Proposal 1.

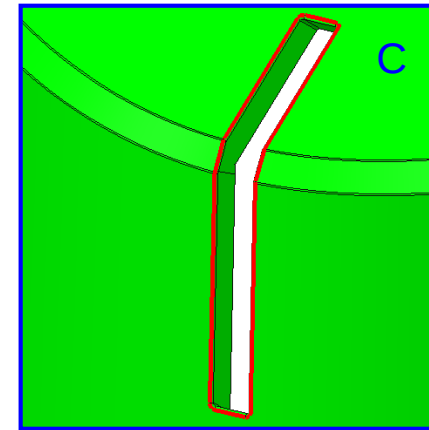
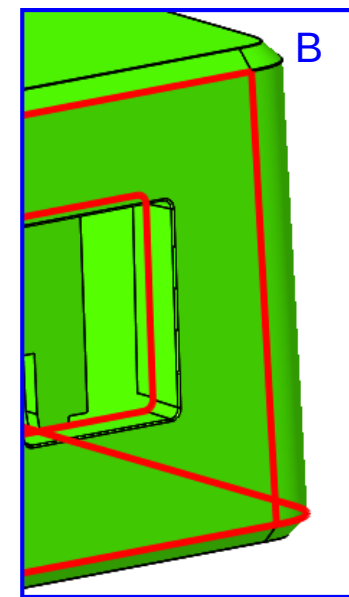
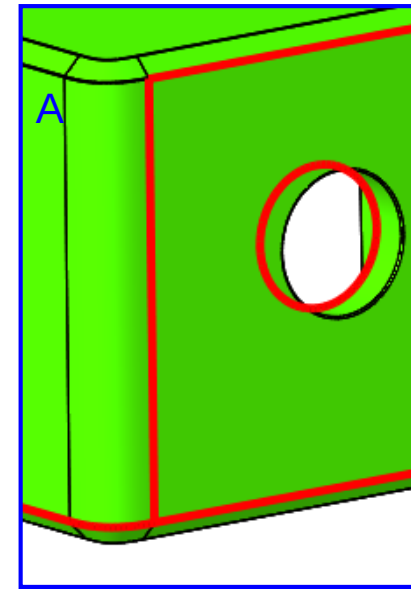
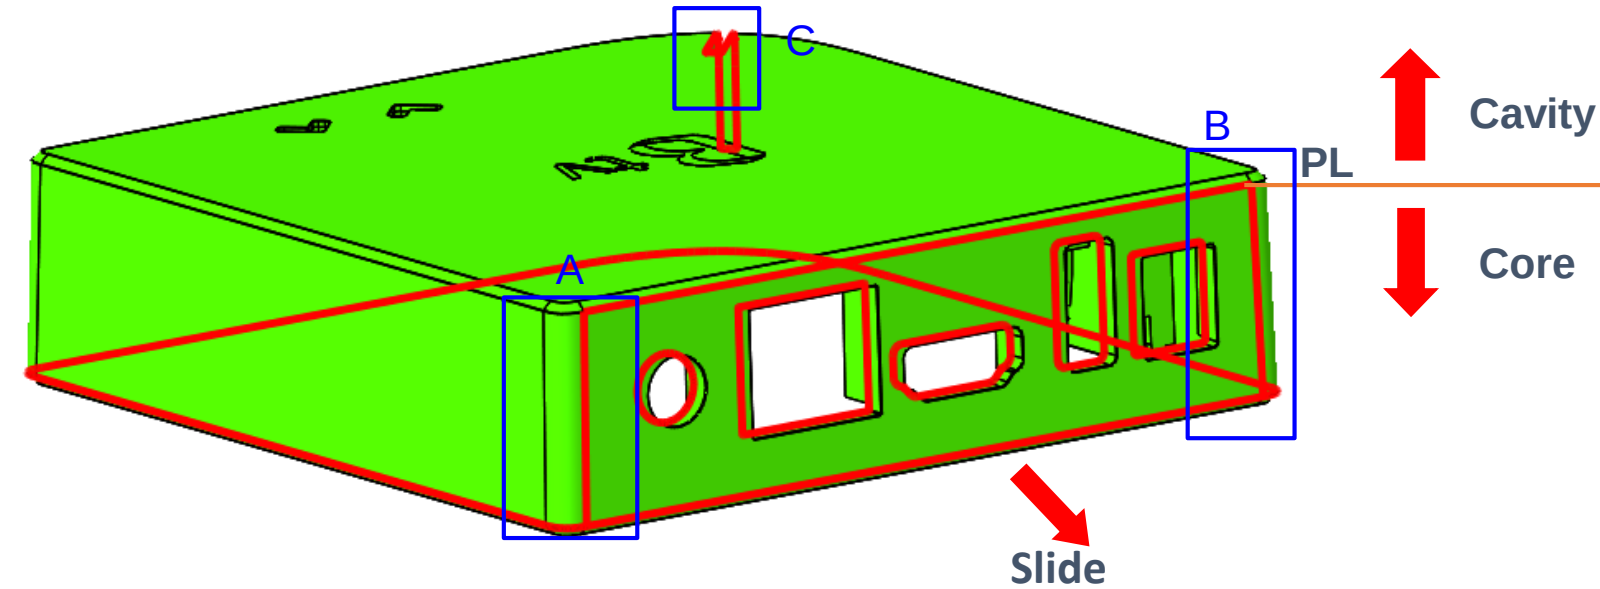
- (1) Run the slider all around the top cover, the slider line as show as below, the height of slider line will not exceed 0.05mm.
- (2) All the sides can stay vertical, as picture F shows.

The red line is slider line, the slider withdraw along arrow direction.

Proposal 2.

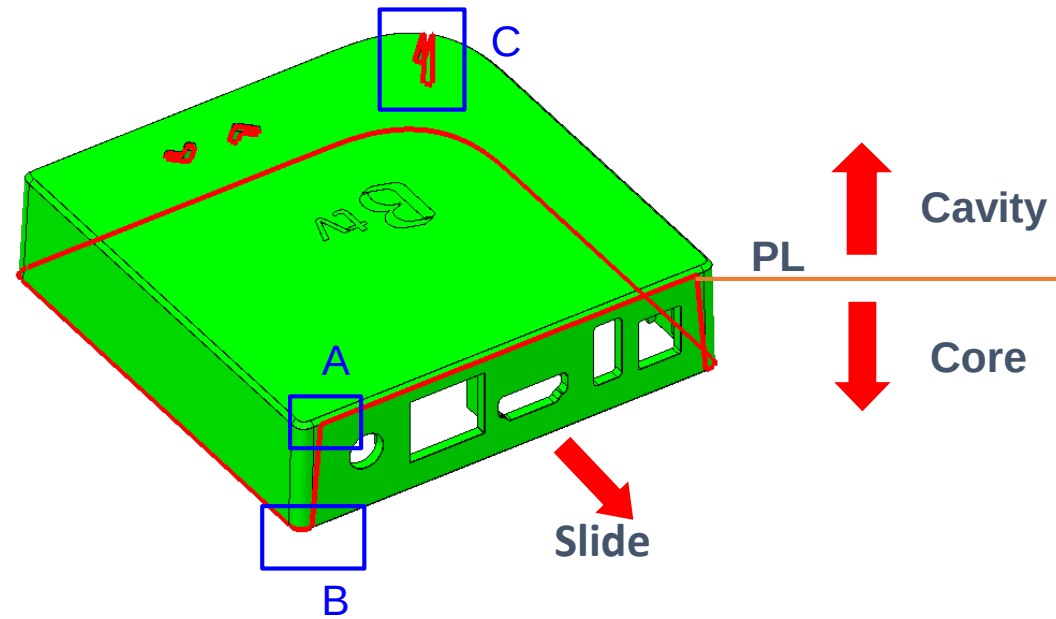
- (1) Draft 3° for all the sides, as picture D shows.
- (2) Only run the slider on the IO side, the slider line as show as below, the height of slider line will not exceed 0.05mm .

The red line is slider line, the slider withdraw along arrow direction.
